Product Line In Vehicle Networking (PL IVN):
HS-CAN transceiver datasheet update to support
CAN FD up to 5 Mbit/s
Attachment to Customer Information Notification (CIN) 201605003I

Date: June 9th 2016

The third generation of NXP's PL IVN HS-CAN transceivers will receive a datasheet update, to support the new CAN FD requirements up to 5 Mbit/s.

Figure 2: Wake-up timing diagram for devices that wake-up through a 3-pulse WUP

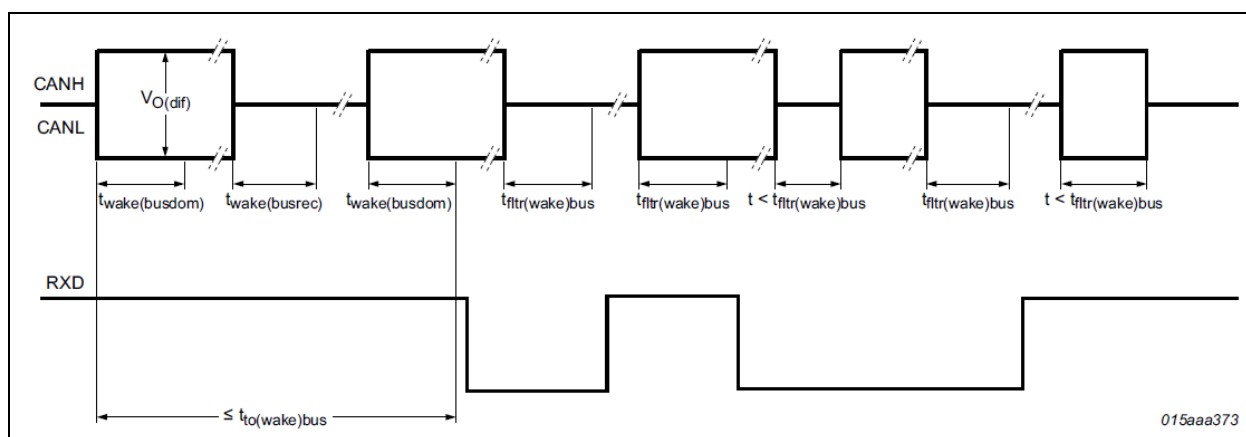
TJA1044, TJA1046 and TJA1049 are devices that wake-up through a 3-pulse dominant-recessive-dominant Wake-Up Pattern (WUP) on the bus, as defined in ISO11898 and shown in Figure 2 below. For the 3-pulse WUP to be valid, the dominant/recessive pulses need to be longer than $t_{wake(busdom)}/t_{wake(busrec)}$ and the pattern needs to be received within $t_{to(wake)bus}$.

That the parameter $t_{to(dom)bus}$, bus dominant time-out time, is redundant for these products can be understood as follows:

- The bus dominant time-out function only works in standby mode of the device, and is disabled as soon as a valid WUP is detected (see below extract from the previous revision TJA1044 datasheet).

- For a device without WUP in standby mode:
 - If a bus dominant pulse is longer than $t_{wake(busdom)}$, RXD goes low.
 - After the bus dominant time-out time $t_{to(dom)bus}$ has passed, RXD goes high again.
- For a device with WUP in standby mode:
 - RXD will only go low after a valid 3-pulse WUP (see Figure 2 above)
 - Once a valid WUP has been received, the device will go in normal mode and the bus dominant time-out function is no longer active.
- In conclusion, a bus dominant time-out time $t_{to(dom)bus}$ is a redundant parameter for devices that wakes up through a 3-pulse WUP, like TJA1044, TJA1046 and TJA1049.
